NOTIFICATION OF ADDENDUM

ADDENDUM NO. 1

DATED 7/27/2021

Control	<u>2121-04-114, ETC.</u>
Project	<u>CBI 2021(797), ETC.</u>
Highway	<u>IH 10</u>
County	<u>EL PASO</u>

Item 360 – Concrete Pavement

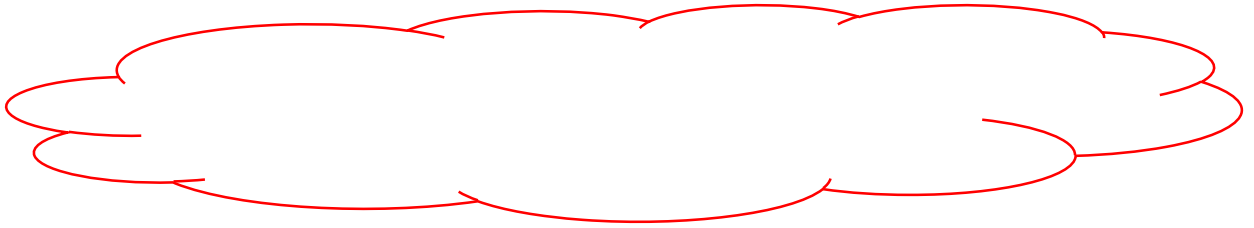
REVISED GENERAL NOTE FOR ITEM 360

A pre-paving meeting will be required. Submit a paving plan detailing the location of joints and the sequence of paving for approval to the Engineer at least seven days before the pre-paving meeting.

Only multiple piece tie bars, as described in Section 360.2.2.2, “Tie Bars,” and as noted on Standard sheet “Continuously Reinforced Concrete Pavement,” CRCP (1)-20, will be used at longitudinal construction joints and only threaded couplings will be permitted for these tie bars.

Item 3076 – Dense-Graded Hot-Mix Asphalt

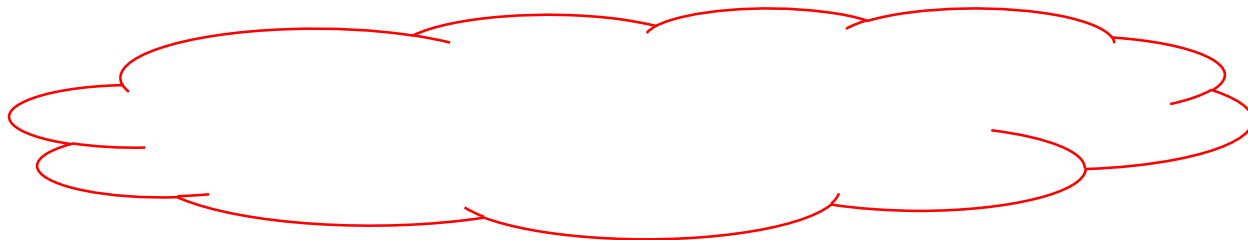
REVISED GENERAL NOTE FOR ITEM 3076

Hydrated Lime shall be added as an additive as per Item 301 “Asphalt Antistripping Agent” between the rates of 1.0% minimum and 2.0% maximum by weight. If the Hamburg Wheel Test cannot be met within these limits, Liquid Antistripping agents as approved by the Engineer may be used in conjunction with lime.
